# UNITED STATES PATENT AND TRADEMARK OFFICE

APPLICATION NO.	FILING DATE	FIRST NAMED INVENTOR	ATTORNEY DOCKET NO.	CONFIRMATION NO.
10/602,582	06/24/2003	John J. Breen	16356.803 (DC-04938)	1625
27683	7590	04/26/2006	EXAMINER	
HAYNES AND BOONE, LLP 901 MAIN STREET, SUITE 3100 DALLAS, TX 75202			TIBBITS, PIA FLORENCE	
			ART UNIT	PAPER NUMBER
			2838	
DATE MAILED: 04/26/2006

## Office Action Summary

### DETAILED ACTION

and in fig.1:

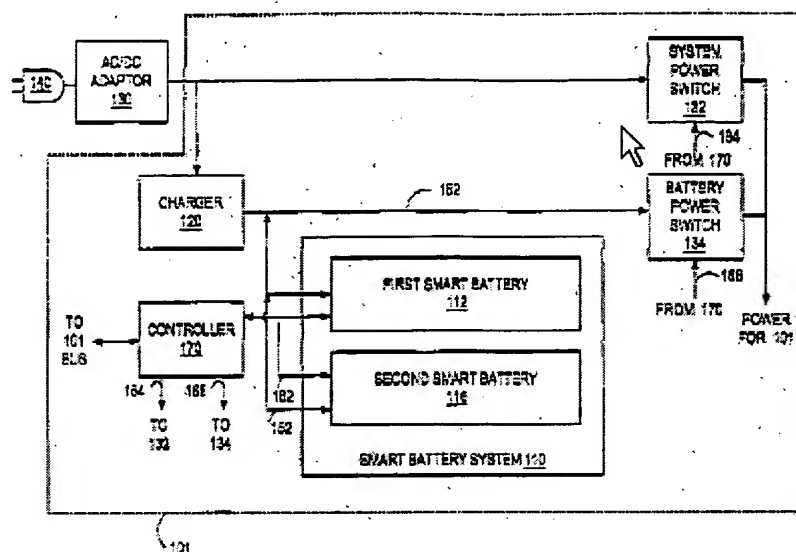
7. Applicant's arguments with respect to the claims have been considered but they are not persuasive: applicant amended claims 17 and 24 to include "the charge and discharge switches being opened in response to the electronics device and the controller being in agreement to charge one of the smart batteries, and either of the charge or the discharge switches being opened in response to directions from the electronics device or the controller", which is new issue.

The instant application describes in the specification at paragraph 0033:

"To advantageously reduce occurrences of operating conflicts during a charge operating condition switches 114 and 115 are closed when both, the smart electronics 113 and the controller 170, agree that the first smart battery 112 is in the charge operating condition. When both are in agreement the smart electronics 113 generates outputs, which result in closing switches 114 and 115, the outputs being transferred via control lines 182 and 183. In case of a disagreement, the logic i.e., the operating condition determined by the smart electronics 113 prevails. Operation of switches 118 and 119 is similar. For example, when the controller 170 instructs the first smart battery 112 to charge but the first smart battery 112 is already fully charged then the first smart battery 112 is able to override the request from the controller 170 to prevent an overcharge condition. Similarly, if the controller 170 instructs the first smart battery 112 to charge but the battery 112 detects an over current or over temperature condition then the battery 112 is operable to disconnect itself and terminate the charge request",

The '482 reference describes in fig.3:

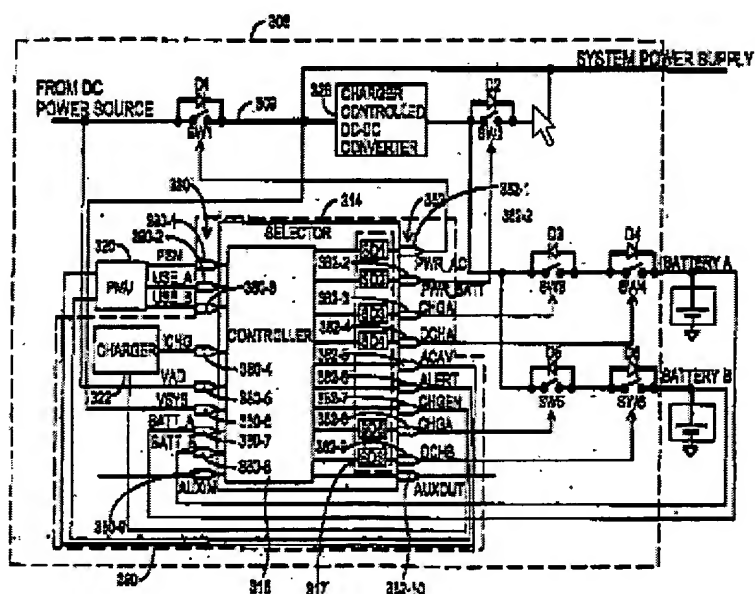
Therefore, the controller and the Smart Battery communicate with each other and operate according to feedback, so that the two circuits are equivalent. See *MPEP* §§ 2183- 2184.
